WCC Accessibility Audits Tawa Community Centre

703771/01

Wellington City Council (WCC) engaged CPG NZ Ltd (CPG) to undertake an accessibility audit on the Tawa Community Centre. The centre is a hub for the many community activities and services available to the population of Tawa.

Existing accessible carparks (east)

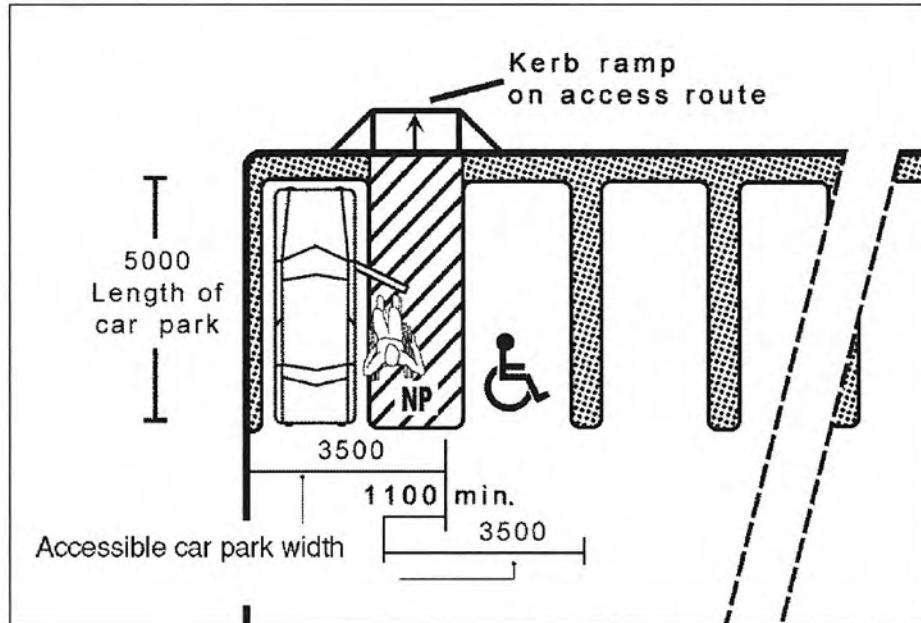
- The accessible park located on the south side of the centre in front of the council chambers is fully non-compliant and non-functional. A car parked in this space will block the access ramp, requiring the user to walk along the road to access the community centre.

- The southern “accessible” carpark has signage located at a height well above the recommended positioning of 750 - 1200mm from ground level.
- The painted markings on all accessible carparks are very worn and faded, which makes them difficult to see at a distance.

- The eastern accessible carparks have no signage.
- The eastern accessible carparks have no direct accessible route to the front of the building therefore forcing users to travel out onto the road to get front access from these parks.

- No kerb ramp has been provided onto the footpath from the eastern parks. This forces users to travel out onto the road to get access to the community centre from these parks.

- The length dimension of the eastern accessible carparks is 4450mm. This is 550mm less than the min 5000mm.

- That the southern accessible carpark space be abandoned and that the 2 carparks on the eastern side be upgraded to replace this park.
- Upgrade existing eastern accessible carpark spaces to have compliant dimensions, repaint markings, install kerb ramps and signage.

No kerb ramps present, East Side

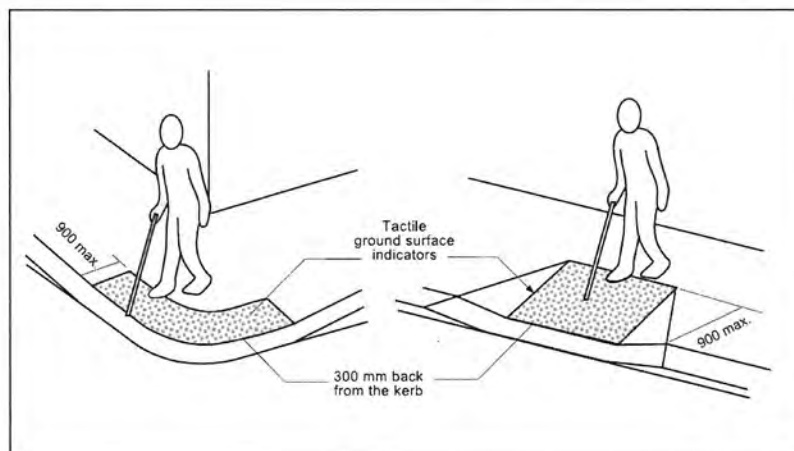
- The Tawa Community Centre does not provide compliant kerb ramps for pedestrians. In particular kerb ramps should be installed for the eastern accessible car parks to provide access into the Community Hall entrance. This is achievable currently by using the ramped seal at the southern end of the carpark, as pictured above. However, usage of this requires the user to navigate into traffic and have prior knowledge that this ramped area of seal is present.

- Install kerb ramps with tactile indicators between the two accessible carparks in the eastern carpark which meet the requirements of either NZBC section D1/AS1 3.4 fig.10, or NZS4121 section 13.4.3 fig.46. Tactile indicators help maintain independence, wayfinding and the safety of visually impaired and blind people.

Community Hall and Community Centre connection ramp

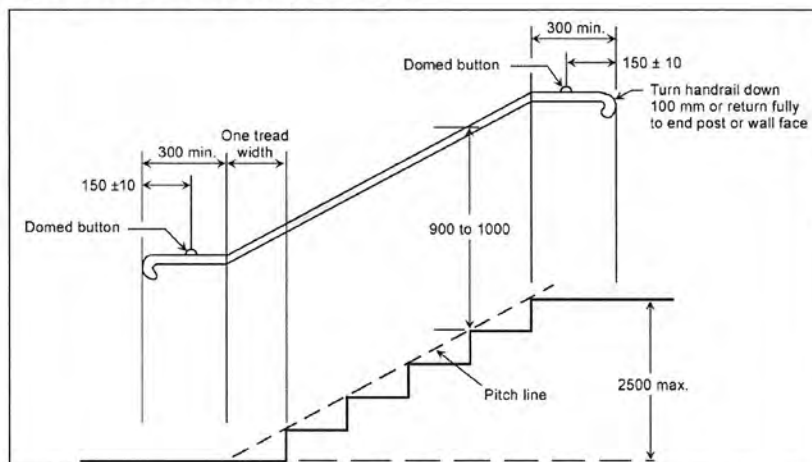
- Handrail projects into the width of the ramp giving a clear width of 1010mm, which is less than the minimum clear width of 1200mm.
- The handrail has no downturn where it terminates. The downturn indicates its imminent termination and is critical to a person with vision impairments.
- The handrail is not continuous at the top landing.

- Install returns onto end of handrails or have them returning into the wall. Installing a domed button 150mm from the end of the handrail indicating its imminent termination while not fully compliant may be an easier way to lessen non-compliance.
- Widen ramp so that clear width is 1200mm

Chambers entry

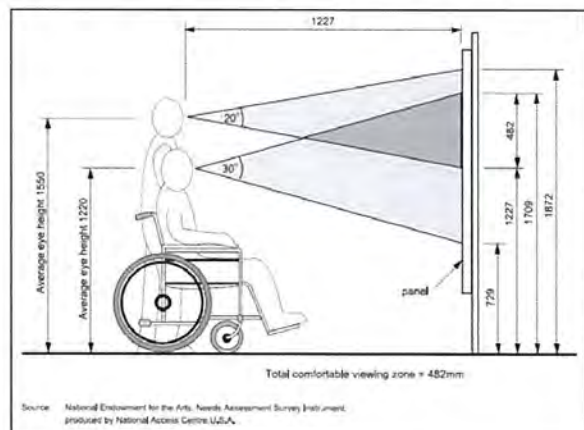
- Glazing where it could be mistaken for an unimpeded path of travel, such as the glass panels surrounding the hall area or the side panels of the chambers entry lack manifestations. Manifestations help persons with visual impairments by providing additional contrast on transparent surfaces.
- Signage throughout the Community Centre is sparse and is generally located outside of the complying height zones on the accessible route where it is present.

- Install manifestations on all full height glass panels located by entry doors, all the southern and eastern perimeter glass panels in the town hall/community centre areas areas.
- Install more directional and informative signage or relocate existing signage to a height within the recommended range below.

Plan Layout of accessible toilets

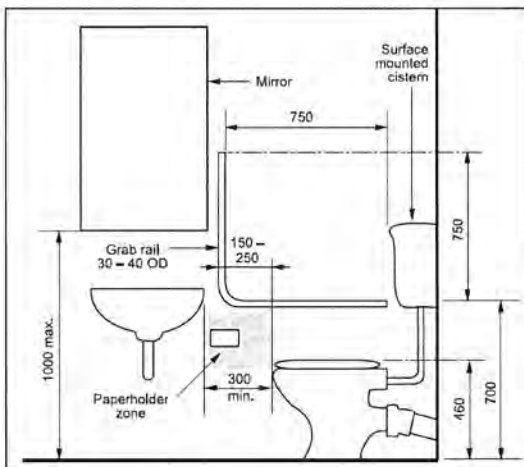
- No washbasin has been provided within the toilet cubicles.
- The door latch on the female facility was difficult to lock in place with one hand.
- Hooks for hanging items on have been installed well above the recommended accessible height of 1200mm from floor level, and are therefore unusable to persons with mobility impairments.
- The accessible toilet within the cubicle has no signage
- Directional signage to the facility is inadequate.
- Entry doors to the toilets do not have a horizontal grab rail to the back of the door. A grab rail assists users with pulling open the door.
- Due to the angled arrangement of the toilet cubicles, they do not meet the minimum dimensions of 1600 x 1900mm required for an accessible cubicle. See sketch below.

- Lower hooks in main toilet area to be 1200mm from floor level so that they are easily reachable.
- Install hooks within the accessible toilet cubicles at 1200mm from floor level.
- Consider installation of accessible facilities for the community hall area as part of future developments that may be planned.
- Install a compliant basin and mirror within the toilet cubicle as per the below details from NZS4121.
